UNIVERSITY SURVEY & ADA EVALUATION

Priority 1 - Parking

Customer XYZ

Bldg Example 100

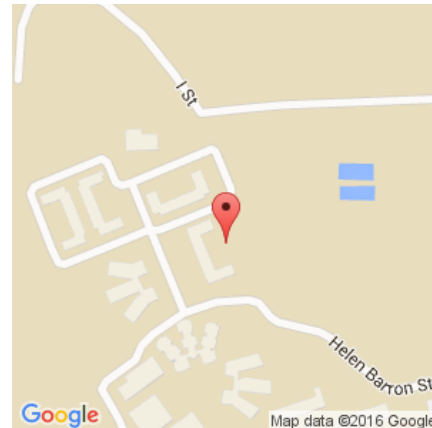
Comments: Findings - The access space is 9 feet 2 inches and the access aisle is 60 inches or 5 feet.

Comments: Findings - The access space is 11 feet and the access aisle is 5 feet.

Comments: Findings - The signs range from 57 inches to 60 inches.

Value: The signs must be raised and I also recommend repainting the accessible parking spots.

Bldg Example 100

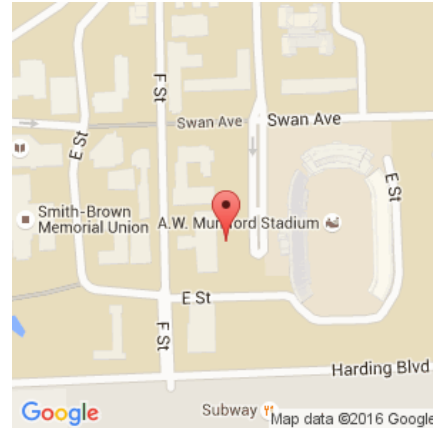
Value: This area is accessed by persons who live in the building and the public. However the parking area is 100% out of compliance with any parking requirements

Value: There is no accessible parking at the rear or west side of Reed Hall

Value: The ground is not properly sloped for any particular transportation requirement. However it can be made to slop correctly

Value: There are no adjoining accessible Aisles

Value: No symbol exist at this location

Value: Such as resurfacing the parking area and placing the appropriate signs. Or, put up sign stating no parking.

Bldg Example 12

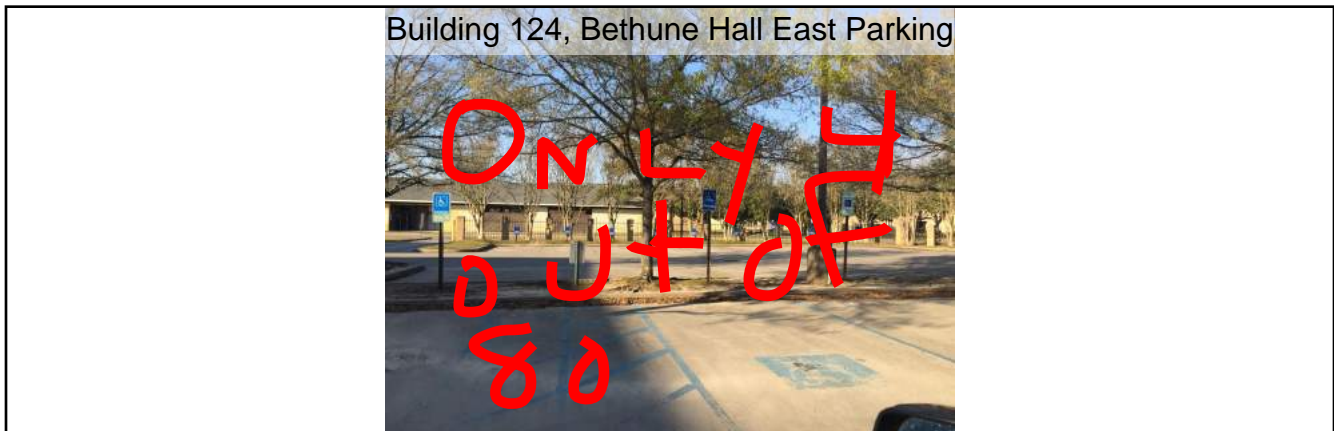
Comments: There are only four out of 80 parking spaces that are for the handicapped.

Value: Yes, but they could be updated to reflect stronger color

Value: No

Value: More handicapped parking spaces are needed. Accessible lanes to the building should be provided. Access ramp to the building needs to be better marked, and it should include visual ridges feel ridges for the visually impaired
